HOPKINTON ESTATES SUBDIVISION

APPLICATION NUMBER 1 DATE November 15, 2007

DETAIL SITE PLAN

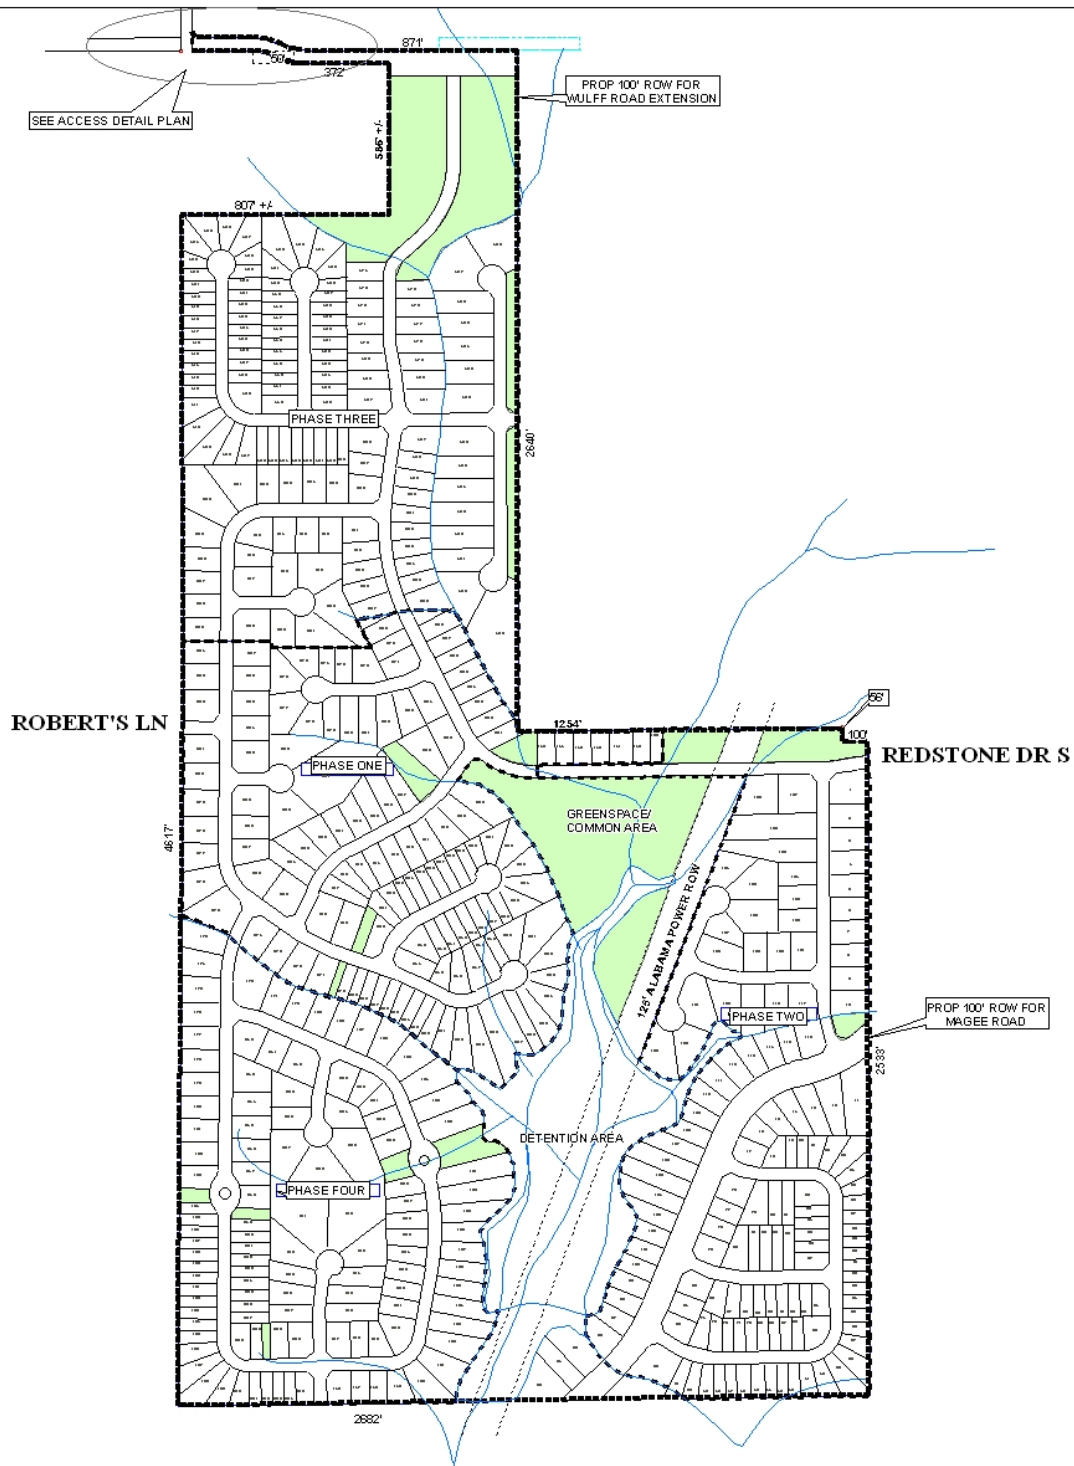
The applicant proposes to create 503 lots, of which approximately 193 lots will “typically” be approximately 6,300 square feet in size, which is less than the 7,200 square feet required by Section V.D.3. of the Subdivision Regulations. The plat appears to depict lots as small as 5,850 square feet. No justification has been provided for the reduced lot sizes.

The plat also shows areas of “green space” and then other areas with no indication of use, including a corridor that implies a utility easement. No area calculations have been provided regarding “green space” or other space set aside for common areas.

The site is bisected by two proposed major streets, Wulff Road Extension and Magee Road. Each proposed major street should have a minimum right-of-way of 100 feet, however there is no indication of the proposed subdivision accommodating the proposed major streets.

The proposed 503 lot subdivision will only have connections to two existing minor streets, although the connection to the existing Robert’s Lane is drawn in the wrong location. Three to four other street-stubs are depicted on the plat, however, they would connect to undeveloped land.

The site is bisected by a branch of Hamilton Creek, thus wetlands may be present on the site. The potential presence of wetlands indicate that the area may be environmentally sensitive; therefore, the approval of all applicable federal, state and local agencies would be required prior to the issuance of any permits or land disturbance activities.

- 1) The plat does not include the entirety of parent and child parcels for parcel R022407260000094., and no evidence has been provided that the child parcels should not be included as part of the application;
- 2) Numerous lots will not meet the minimum size requirements of Section V.D.3. of the Subdivision Regulations, and no justification has been provided for the reduced lot sizes;
- 3) No calculations have been provided for “green space” and other unlabeled, undeveloped portions of the site; and
- 4) There are errors in the drawing.

- 1) Provision of connections to Roberts Lane and Redstone Drive South, with internal links to each street, by the recording of the second phase (second plat) of the development, if developed in phases;*
- 2) Labeling of all green space common areas as such;*
- 3) Renaming of the detention area to "detention common area";*
- 4) Placement of a note on the final plat stating that the maintenance of all common areas shall the responsibility of the property owners;*
- 5) Compliance with the requirements of the 2003 International Fire Code, including Appendices B through D, as adopted by the City of Mobile, particularly as applied to the subdivision layout, design and road construction, to be verified by Mobile Fire-Rescue;*
- 6) Dedication of the roads to Mobile County;*
- 7) Depiction of the 25-foot minimum building setback line on all lots and common areas, on the final plat;*

- 8) *Approval of all applicable federal, state and local agencies for wetlands prior to the issuance of any permits or land disturbance activities;*
- 9) *Placement of a note on the final plat stating that the development will be designed to comply with the storm water detention and drainage facility requirements of the City of Mobile storm water and flood control ordinances, and requiring submission of a letter from a licensed engineer certifying that the design complies with the storm water detention and drainage facility requirements of the City of Mobile storm water and flood control ordinances prior to the signing of the final plat. Certification is to be submitted to the Planning Section of Urban Development and County Engineering;*

- 10) *Placement of a note on the final plat stating that each lot is limited to one curb-cut, with the size, design and location to be approved by Mobile County Engineering Department;*

- 11) *Placement of a note on the final plat stating that common areas with less than 200 feet of road frontage are limited to one curb-cut, and that all other common areas are limited to two curb-cuts, with the size, design and location to be approved by Mobile County Engineering;*

- 12) *Revision of the plat to label each lot with its size in square feet, or placement of a table on the plat with the same information; and*
- 13) *Placement of a note on the final plat stating that any lots which are developed commercially and adjoin residentially developed property must provide a buffer, in compliance with Section V.A.7 of the Subdivision Regulations.*

DETAIL SITE PLAN

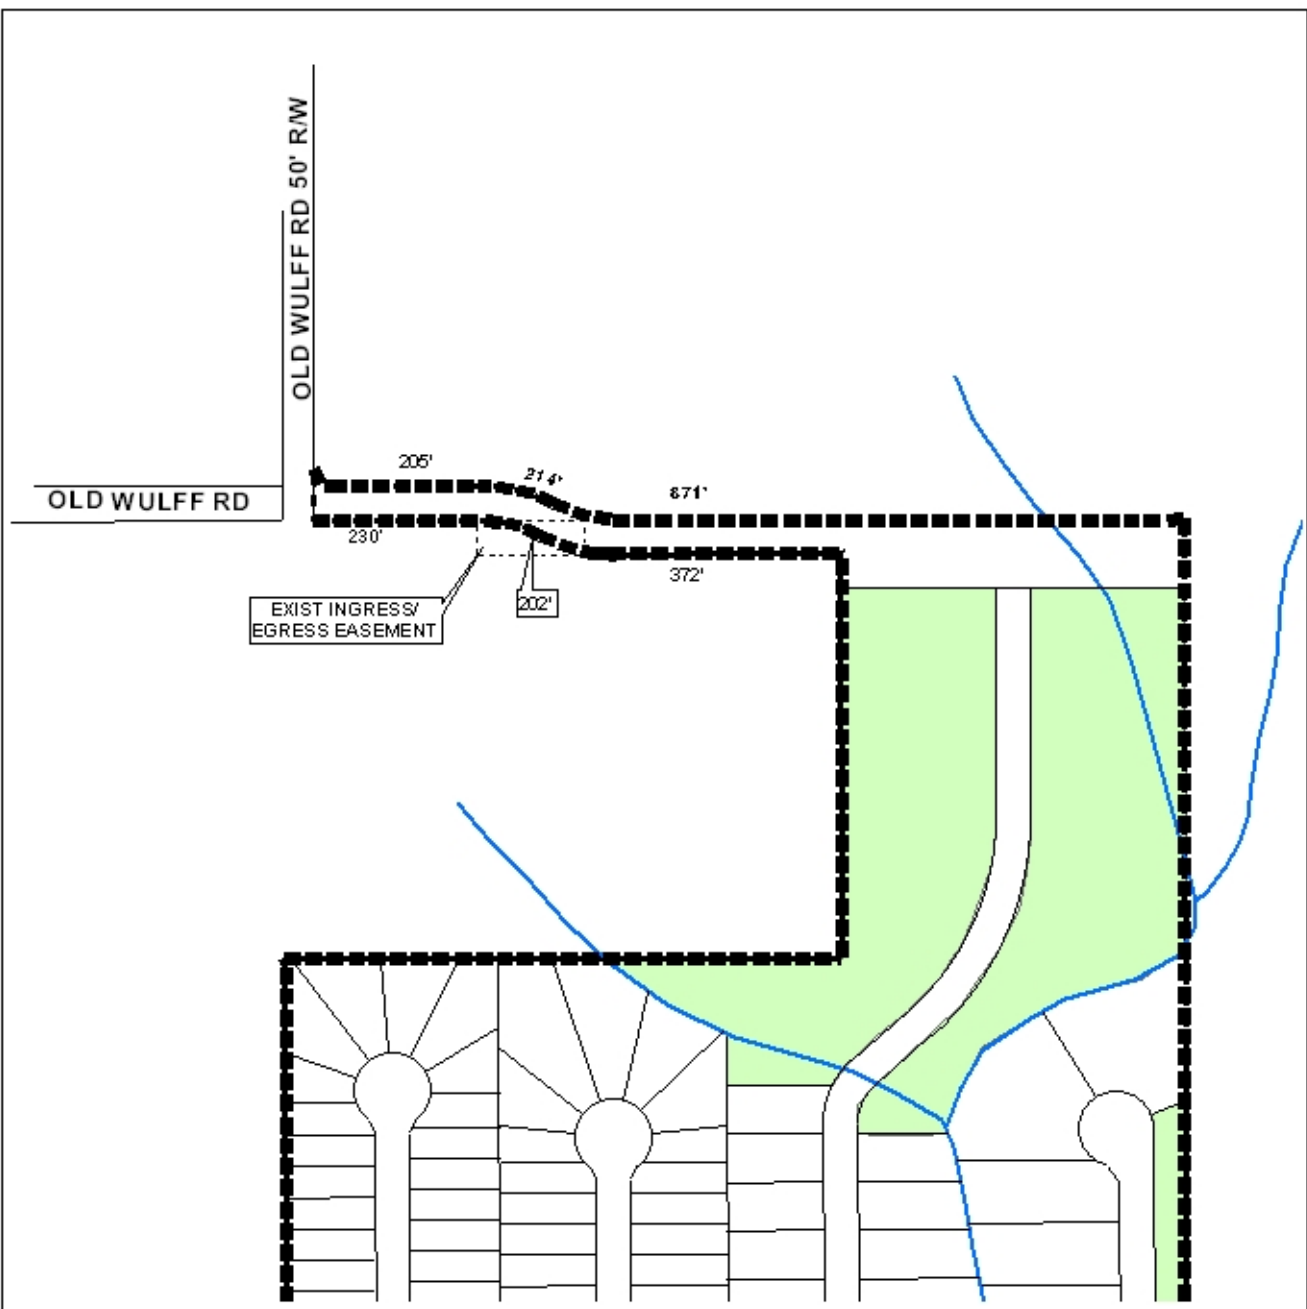
The revised plat depicts a 4 phased development that includes additional, direct access to Old Wulff Road.

The addition of direct access to Old Wulff Road encumbers three additional parcels / lots not previously included in the original application. The full extent of these additional parcels / lots needs to be included in the application, and additional postage and labels for notification, and

lots fees for the additional lots that must be created should be included for the expansion of the application.

- 1) The additional access provided to Old Wulff Road necessitates additional postage, labels and lot fees, as well as notification of the public, none of which has been provided by the applicant; and*
- 2) The statement regarding adequate access does not represent a Traffic Impact Study, and thus does not adequately address concerns raised by the Planning Commission.*
